**LEE'S SUMMIT**  
MISSOURI  
Development Services Department

## Development Services Staff Report

<b>File Number</b>	PL2022-283
<b>File Name</b>	SIGN APPLICATION – Cobey Creek monument signs
<b>Applicant</b>	Clayton Properties Group, Inc.
<b>Property Address</b>	499 and 501 SE M-150 Hwy
<b>Planning Commission Date</b>	October 13, 2022
<b>Heard by</b>	Planning Commission
<b>Analyst</b>	C. Shannon McGuire, Planner
<b>Checked By</b>	Hector Soto, Jr., AICP, Senior Planner

Figure 1. UDO required monument sign measurement area, 188 sq. ft.

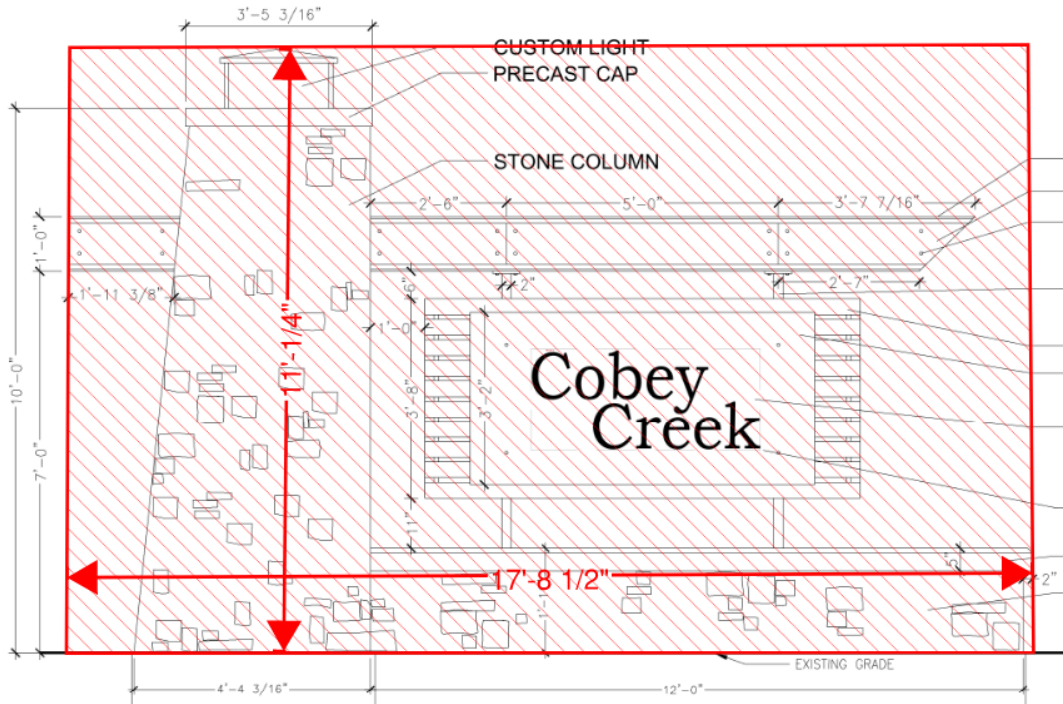
The UDO only provides for a single method when calculating the total monument sign area. For freestanding signs, the sign structure area includes every part of the sign, including the sign area, plus all other elements of the sign, including supports, uprights, base, frame, decorative and design elements, and any open space contained within the limits of the rectangle delimiting the sign structure. Simply put, the UDO requires the area of a sign be calculated as Height x Width, (Figure 1). While this is an effective method for calculating the total sign area of rectangular shaped signs, it is an overly simplistic method when trying to calculate the total area of signs with an irregular shape. Using this method of measurement, the proposed signs are each 92 sq. ft. over the UDO standards.

1. Four (4) 188 sq. ft. monument signs shall be allowed, as depicted on the sign elevations and site plan sheets, dated September 8, 2022, for Cobey Creek located at 499 & 501 SE MO-150 Hwy. Signage shall comply with all other UDO sign standards of the PMIX zoning district.

Figure 2. Actual monument sign structure area, 104.98 sq. ft.

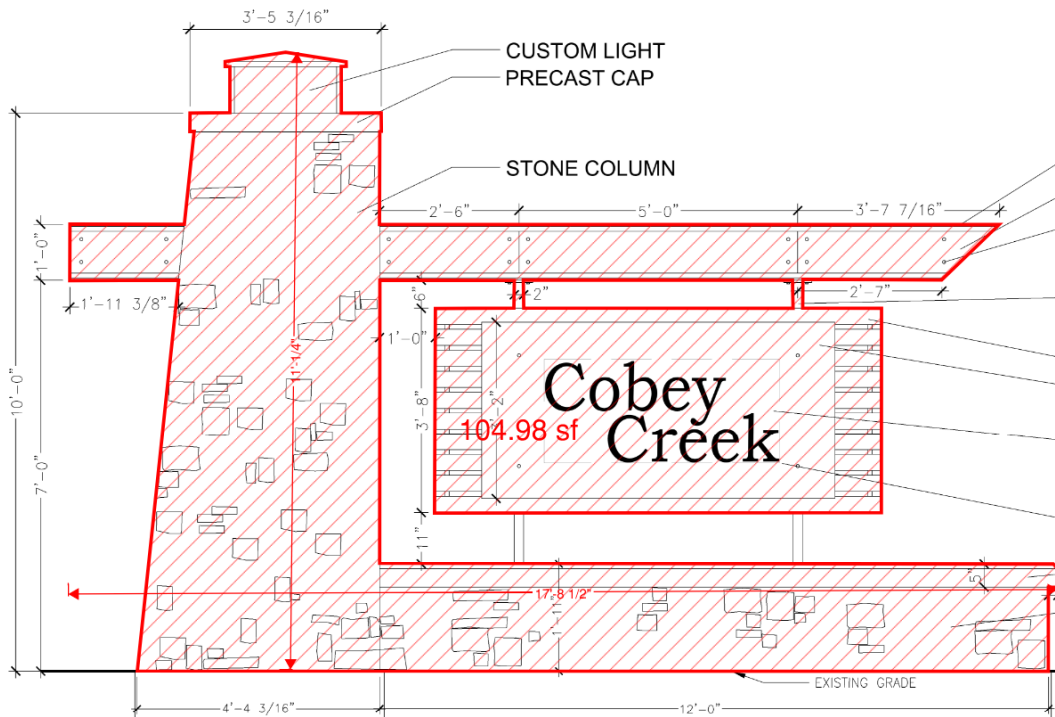
Utilizing the Revu Bluebeam software package, staff can calculate the actual sign face area. This method provides for an accurate calculation of what is being proposed. In this case, the proposed monument signs each have a total sign structure area of roughly 105 sq. ft. (Figure 2). Using this method of measurement, the proposed signs are only slightly larger (9 sq. ft) then what the UDO allows by right.

By using the second method of calculating the sign structure area, the applicant can propose a sign that provides an elevated architectural appearance without being penalized by the simplistic measurement method found in the UDO. Staff believes the proposed monument signs meet the intent of the UDO. For the above stated rationale, staff believes the proposed signs are reasonable and supports the applicant’s request. With the conditions of approval below, the application meets the requirements of the UDO.
